DEVELOPMENT ASSESSMENT REPORT	
<b>Application No.</b>	MOD/2021/0238
<b>Address</b>	95 Grove Street BIRCHGROVE NSW 2041
<b>Proposal</b>	Modification to approved alterations and additions, including changes to fenestration, materials, landscaping, internal modifications, skylight, & condition of consent 7(l)
<b>Date of Lodgement</b>	1 July 2021
<b>Applicant</b>	Edward Sarafian
<b>Owner</b>	Mrs Maureen M Qureshi Mr Christopher M Qureshi
<b>Number of Submissions</b>	20
<b>Value of works</b>	\$827,550.00 (Original Cost of Works)
<b>Reason for determination at Planning Panel</b>	Number of submissions to modification application exceeds 10 Modify Panel imposed condition
<b>Main Issues</b>	Condition 7(l)
<b>Recommendation</b>	Approval with Conditions
<b>Attachment A</b>	Recommended conditions of consent
<b>Attachment B</b>	Plans of proposed development
<b>Attachment C</b>	Consent as modified under MOD/2020/0293

## 1. Executive Summary

**S-04 PROPOSED SECTION**  
- Scale 1:100

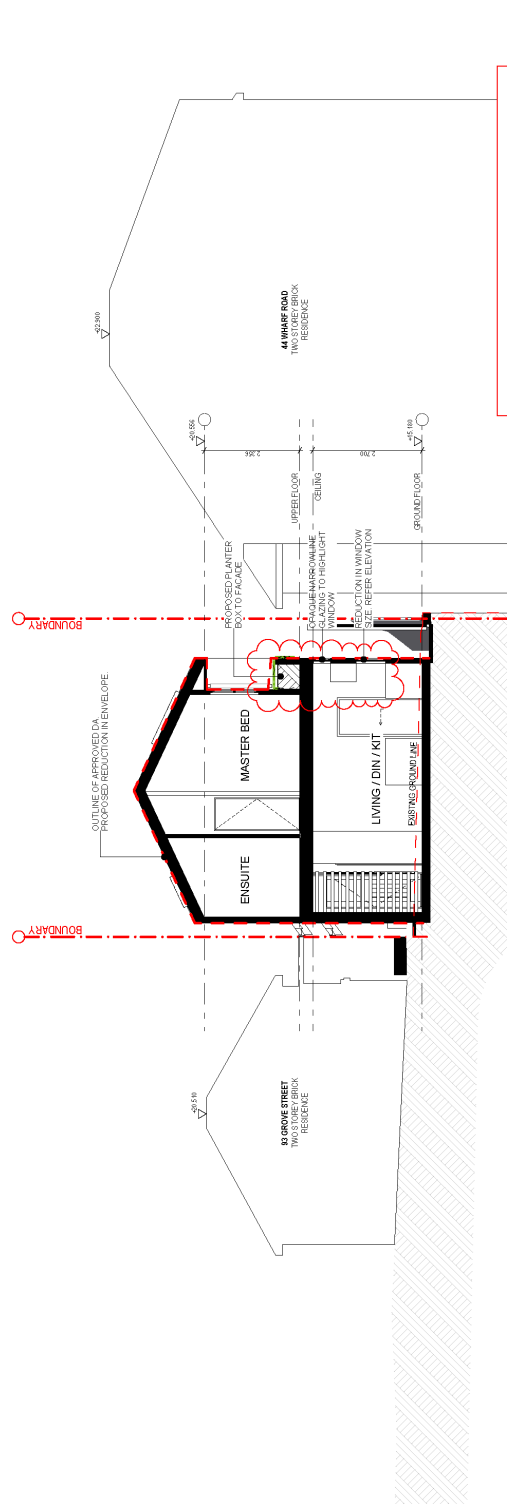
The applicant has sought further clarity of Condition 7 I as part of this application which was imposed by the Panel in its determination of MOD/2020/0293. In this regard, the condition does not refer to the rearmost 3.949m section of the additions the subject of that modification as the section of wall to be setback 900mm. This has resulted in differences in its interpretation as to the portion of the approved rear additions that were required to be setback by 900mm. The intention was the rearmost 3.949m section of the wall and not the entire wall.

The intent of condition 7 I. is to increase the setback of that portion of the additions proposed to be located 609mm that were the subject of modification application MOD/2020/0293. The submitted plans with the current modification application the subject of this report have been altered to reflect that condition.

- ~~l. The setback of the south western wall shall be increased to be a minimum of 900mm from the boundary.~~ The setback of the rearmost 3.949m portion of the south-western wall of the rear additions shall be increased to be a minimum of 900mm from the side boundary.
